SITE PLAN REVIEW

LOT NO. 75 REGISTERED PLAN
THE PROPOSED LOT GRADING AND DRAINAGE IS APPROVED
AS BEING IN CONFORMITY WITH THE OVERALL APPROVED
GRADING PLANS FOR THE SUBDIVISION.

PROJECT/LOCATION
NORTHGLEN PHASE 2
CLARINGTON, ONTARIO

DRAWING
SITE GRADING PLAN

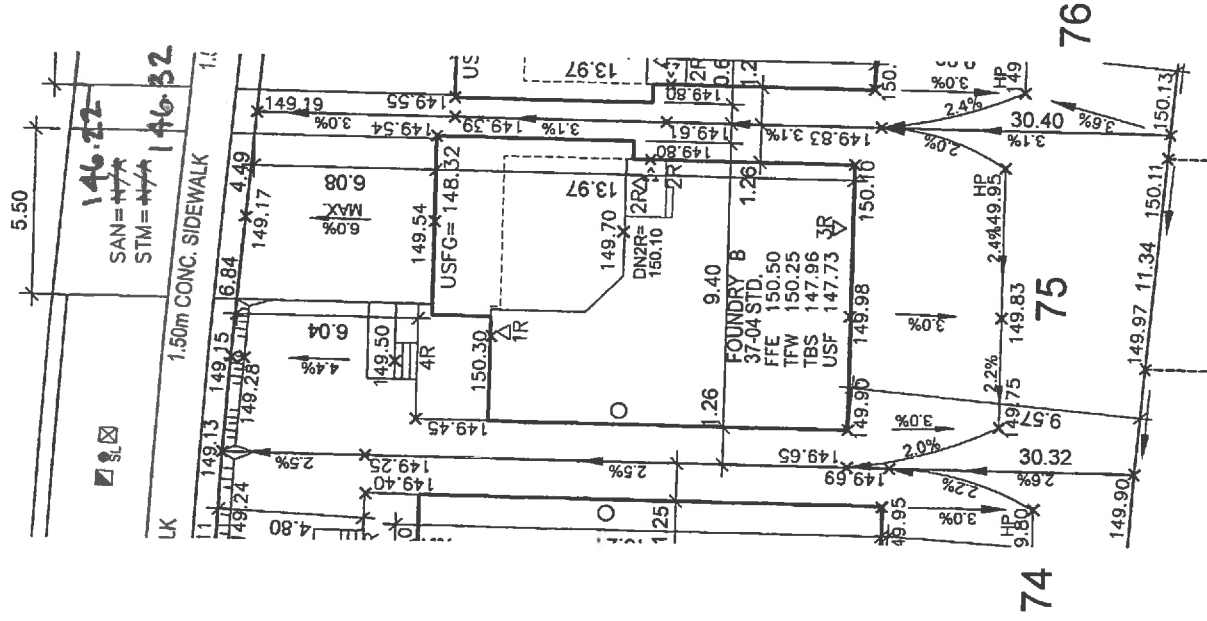
THIS PROPOSAL CONFORMS WITH THE MUNICIPALITY'S GRADING CRITERIA AND APPROVED SUBDIVISION MASTER LOT GRADING PLAN AND THE PROPOSED HOUSE TYPE IS COMPATIBLE WITH THE GRADING. THE PROPOSED DRIVEWAY LOCATION DOES NOT CONFLICT WITH ADJACE DRIVEWAYS, WALKWAYS, CATCHBASINS, HYDRANT, VALVE OR ANY STREET UTILITY.
